COMMENTS ON AN ANNEX XV DOSSIER FOR IDENTIFICATION OF A SUBSTANCE AS SVHC AND RESPONSES TO THESE COMMENTS

Substance name: Medium-chain chlorinated paraffins (MCCP) [UVCB substances consisting of more than or equal to 80% linear chloroalkanes with carbon chain lengths within the range from C14 to C17]

These substances are proposed to be identified as meeting the following SVHC criteria set out in Article 57 of the REACH Regulation: PBT (Article 57d) vPvB (Article 57e)

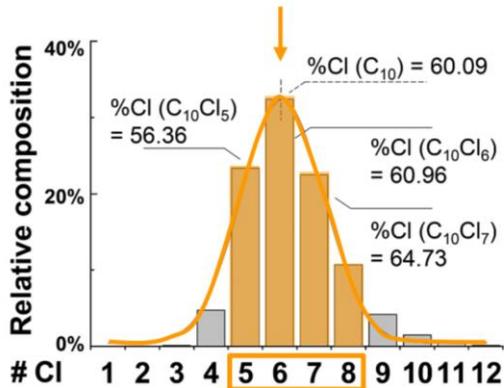
Number / Date	Submitted by (name, submitter type, country)	Comment	Responses
		<p data-bbox="707 667 1346 730"><u>ATTACHMENT COMMENTS ON PAGE 6, PARAGRAPH 1</u></p> <p data-bbox="707 762 1346 863">Figure 1: Graphical Presentation of GCxGC-ECD results of Chlorinated Tetradecane (50% CI)</p> <p data-bbox="707 895 1346 1342">The Consortium also notes that ECHA has in several places made assumptions about the presence of congener groups and the relative amounts of these congener groups in studies where there were no chemical analyses for congener groups. For example, in Section 3.1.2.1.2 (pages 31-47) of the SVHC proposal there are numerous comments about the expected congener groups present in various test materials used in the Closed Bottle Test (CBT) though congener group data were only developed on the 2018 CBT studies, not on those conducted 2010 and 2014. Such an assessment gives more apparent weight to</p>	<p data-bbox="1368 344 2089 568">chlorinated paraffins: A predicted NMR pattern matching framework for isomeric discrimination in complex contaminant mixtures. Environmental Science and Technology Letters, 7, 496–503. Available at: https://pubs.acs.org/doi/pdf/10.1021/acs.estlett.0c00244</p> <p data-bbox="1368 608 2089 639"><u>ATTACHMENT COMMENTS ON PAGE 6, PARAGRAPH 1</u></p> <p data-bbox="1368 639 2089 1318">The average degree of chlorination of the testing materials is reported in the studies. However, further information on the composition of the testing materials is missing in many study reports. In these cases, we considered a Gaussian distribution to estimate for a given carbon chain length the composition (i.e. compositional profile) of the chlorinated congener groups. The distribution was expected to be centred between the congeners having a chlorine content just above and below the average degree of chlorination of the substance. The chemical analyses of commercial chlorinated paraffins in the literature have confirmed that the composition of chlorinated congeners with a given carbon chain length is following a Gaussian distribution. For a given carbon chain length, the numerical range of chlorine atoms around the peak of the Gaussian distribution was limited to 4 in order to ensure that all the constituents considered are present in proportions well above 0.1% (w/w). Therefore, we consider this is a robust approach.</p>

Number / Date	Submitted by (name, submitter type, country)	Comment	Responses
		congener groups when the key metric in these studies is measured oxygen consumption and the resulting biodegradation of the overall test substance.	See below Figure 1 as an example of Gaussian distribution for a C ₁₀ chlorinated n-alkane, 60.09% Cl wt. (average value). For this chlorinated paraffin, the peak of the Gaussian distribution corresponds to the average chlorination level (60.09% Cl wt). Based on this average chlorination level and using a Gaussian distribution, the 4 predominant congener groups present in C ₁₀ chlorinated n-alkane, 60.09% Cl wt. are C ₁₀ Cl ₅ , C ₁₀ Cl ₆ , C ₁₀ Cl ₇ and C ₁₀ Cl ₈ (all centred around the average chlorination level).

Figure 1. Schematic Gaussian distribution of C₁₀Cl_m in the C₁₀ 60.09% Cl reference standard. The curve is the Gaussian peak, the center of which is 60.09%Cl. The columns represent one possible relative composition of each C₁₀Cl_m calculated from the eq 4 setting σ_i of 0.05.

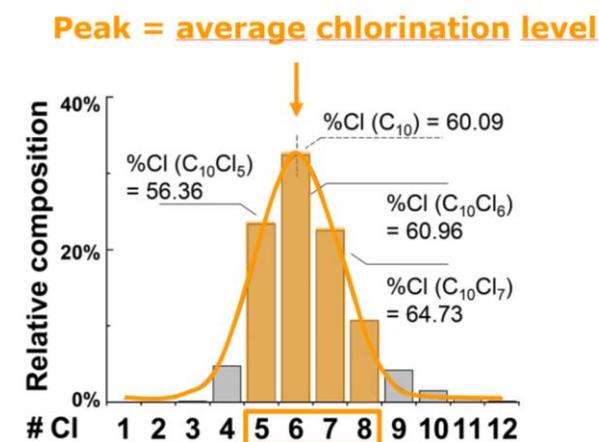
must have been reduced in those studies. Consequently, we propose to modify or delete this sentence.	
5554 2021/04/23	Environment Agency, National Authority, United Kingdom	<p>General comment: Where the text "is expected to contain" [specific congeners] is used in relation to a specific laboratory test, please be clear when this is speculation on the part of the dossier submitter. As noted below, the analytical ability to discern specific congeners is limited, particularly with less than 5 chlorine atoms, and so extrapolating from studies where this level of analysis has been provided is uncertain.</p>	<p>General comment: Text has been added to the support document to specify when the Gaussian distribution has been considered to describe the composition of chlorinated congeners. The average degree of chlorination of the testing materials is reported in the studies. However, further information on the composition of the testing materials is missing in many study reports. In these cases, we considered a Gaussian distribution to estimate for a given carbon chain length the composition (i.e. compositional profile) of the chlorinated congener groups. The distribution was expected to be centred between the congeners having a chlorine content just above and below the average degree of chlorination of the substance. The chemical analyses of commercial chlorinated paraffins in the literature have confirmed that the composition of chlorinated congeners with a given carbon chain length is following a Gaussian distribution. For a given carbon chain length, the numerical range of chlorine atoms around the peak of the Gaussian distribution was limited to 4 in order to ensure that all the constituents considered are present in proportions well above 0.1% (w/w). Therefore, we consider this is a robust approach. See below Figure 1 as an example of Gaussian distribution for a C₁₀ chlorinated n-alkane, 60.09% Cl wt. (average value). For this chlorinated paraffin, the peak of the Gaussian distribution corresponds to the</p>

average chlorination level (60.09% Cl wt). Based on this average chlorination level and using a Gaussian distribution, the 4 predominant congener groups present in C₁₀ chlorinated n-alkane, 60.09% Cl wt. are C₁₀Cl₅, C₁₀Cl₆, C₁₀Cl₇ and C₁₀Cl₈ (all centred around the average chlorination level).
